GM CUSTOMER CARE AND AFTERSALES  
DCS3827  
URGENT - DISTRIBUTE IMMEDIATELY

Subject: Update to Upcoming Safety Recall 15042  
HVAC Connector Wire Failure

Models: 2006-2010 Hummer H3  
2009-2010 Hummer H3T

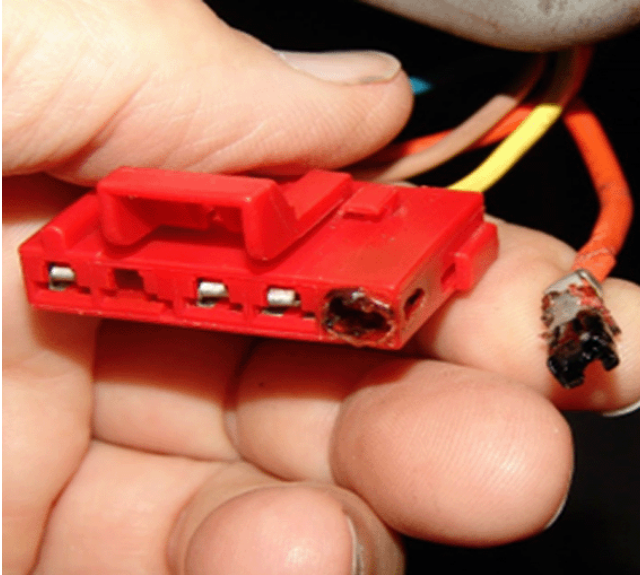
If the female connector to the Blower Motor Resistor assembly exhibits a previous overheat condition, (see photo) replace the harness and resistor assembly with the current replacement parts.
